**PCN#20240829000.1
Qualify OPA607IDBVR/T with additional bond wire
Change Notification / Sample Request**

Date: August 29, 2024

PCN Number:	PCN#20240829000.1	PCN Date:	August 29, 2024
Title:	Qualify OPA607IDBVR/T with additional bond wire		
Customer Contact:	Change Management Team	Dept:	Quality Services
Proposed 1st Ship Date:	November 27, 2024	Sample requests accepted until:	September 28, 2024*
*Sample requests received after September 28, 2024 will not be supported.			
Change Type:			
<input type="checkbox"/> Assembly Site	<input type="checkbox"/> Design	<input type="checkbox"/>	Wafer Bump Material
<input checked="" type="checkbox"/> Assembly Process	<input type="checkbox"/> Data Sheet	<input type="checkbox"/>	Wafer Bump Process
<input type="checkbox"/> Assembly Materials	<input type="checkbox"/> Part number change	<input type="checkbox"/>	Wafer Fab Site
<input type="checkbox"/> Mechanical Specification	<input type="checkbox"/> Test Site	<input type="checkbox"/>	Wafer Fab Material
<input type="checkbox"/> Packing/Shipping/Labeling	<input type="checkbox"/> Test Process	<input type="checkbox"/>	Wafer Fab Process

Current	Proposed
Bond Diagram		
Enable pad to pin 5	No Wire	Single Wire

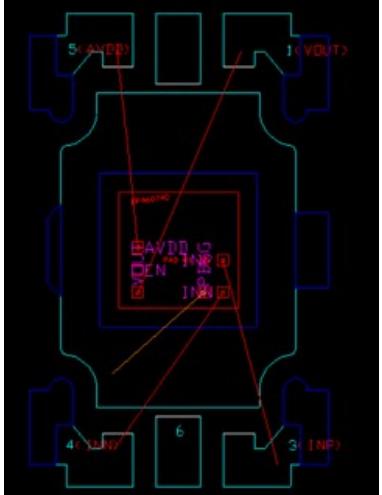
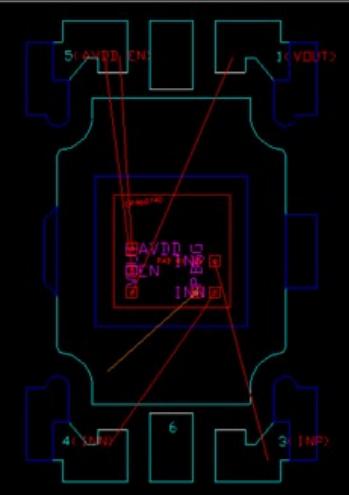
Texas Instruments Incorporated is announcing the qualification of OPA607IDBVR/T for additional bond wire between the VCC pin and Enable pad. Construction differences are as follows:

The pull-up functionality is being strengthened by tying the Enable pad directly to VCC for the 5-pin DBV which does not have an external Enable pin. This ensures the device does not enter a low power state as a result of a process shift in the on-die pull-up resistor.
